Subject: Planning Application 2025/0226/T

Chester Terrace Gardens - retaining wall repair and reconstruction proposals

**Review of various reports regarding
balustrade and retaining wall at
Chester Terrace**

Proposed alternative piling arrangement, with approximate piles loads

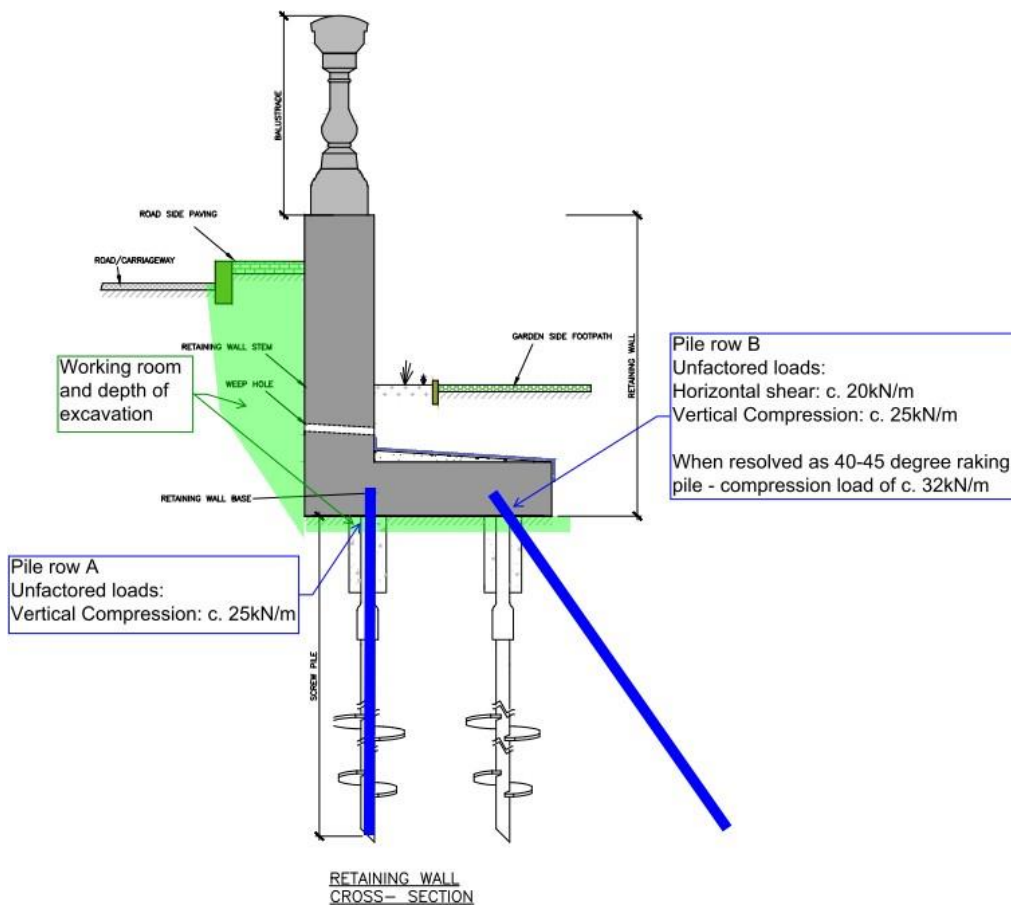
Notably, the method statement suggests that a "21 tonne excavator" is required to install the steel screw piles that will support the new L-shaped reinforced concrete (RC) retaining wall. This would presumably necessitate the destruction of all the mature trees and shrubs in the vicinity. HPM's drawings do not note the required capacities for the piles, however our own calculations show that (all loads here are unfactored) vertical compression loads of around 25kN/m, to each of the two rows of piles, and horizontal shear loads of around 20kN/m, to the outer pile row, are needed to resist the applied forces. If the outer pile row is installed at a 40-45 degree rake from vertical, resolving the forces removes the shear load and it puts the pile essentially in pure compression (and so leaves a far more structurally efficient arrangement), with a load capacity of around 32kN/m required. This arrangement is as shown in the sketch below, with proposed pile rows shown in blue.

Given that screw piles can typically be installed at approximately 500mm centre spacing before adverse group action needs to be considered, it is certainly not unreasonable to assume that screw piles could be installed at 1m centre spacing along each row. This would result in piles needing to take unfactored compression loads in the order of 25-35kN. Having spoken to some screw pile specialists, including Target Fixings (website: <https://targetfixings.co.uk/products/heli-pile/>) it is clear that piles achieving such loads in the London Clay assumed to exist on the site can readily be installed using hand held equipment, for example a 63kg pneumatic driver, and at the 45 degree rake indicated in the sketch above given the available working room. Even if the piles needed to be installed using a 1.5 tonne mini-excavator to get the required torque to reach the necessary capacity, this would still likely be possible with minimal destruction of the local mature flora. The currently proposed use of a 21 tonne excavator to install the piles therefore seems needlessly excessive, destructive, and expensive, for such modest loads that are only, after all, generated from supporting what is a relatively low level retaining wall.

Tree T214 - near Wall 2 - proposed alternative retaining wall arrangement

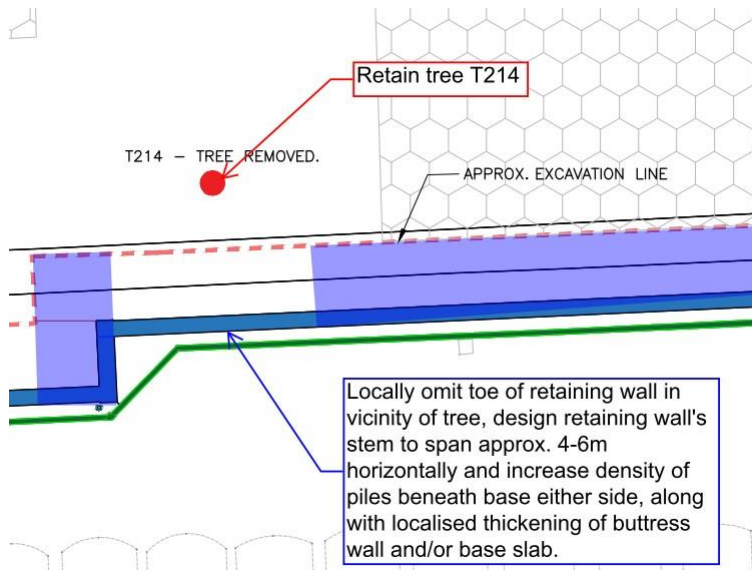
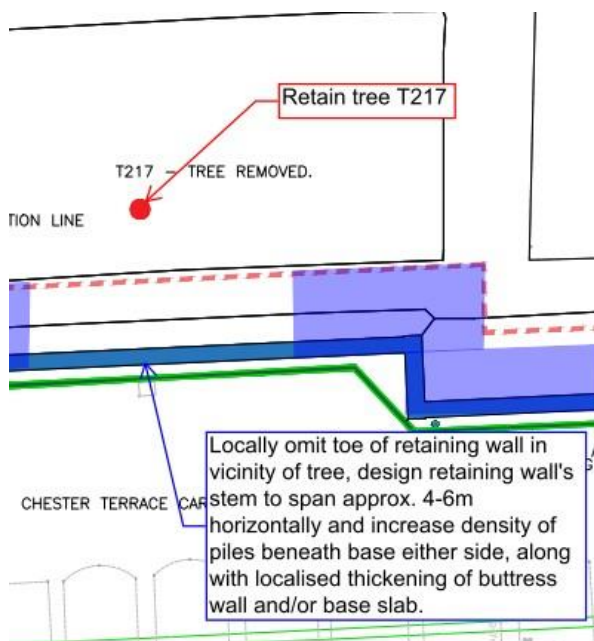
Whilst it is acknowledged that any flora immediately adjacent to where the sections of wall will be replaced will need to be removed, it does appear that an alternative structural arrangement could be pursued local to trees marked T214 and T217 and so not require their removal. Please refer to the two sketches below, which are mark ups of HPM drawing 24509-82 rev P1, showing

the basic principle. The sketches show the toe/base of the retaining wall locally being left out for a 4-6m length of wall in the vicinity of the trees, therefore meaning that the tree roots would remain relatively undisturbed. The new 450mm thick RC retaining wall stem appears to already be thick enough to span this distance horizontally, but it, or the buttressing wall and/or base at either end, could be increased in size if necessary. The density of piles beneath the toe of the retaining wall would also need to be increased at either end, but a detailed analysis of the arrangement and refinement of loads should prove it feasible.
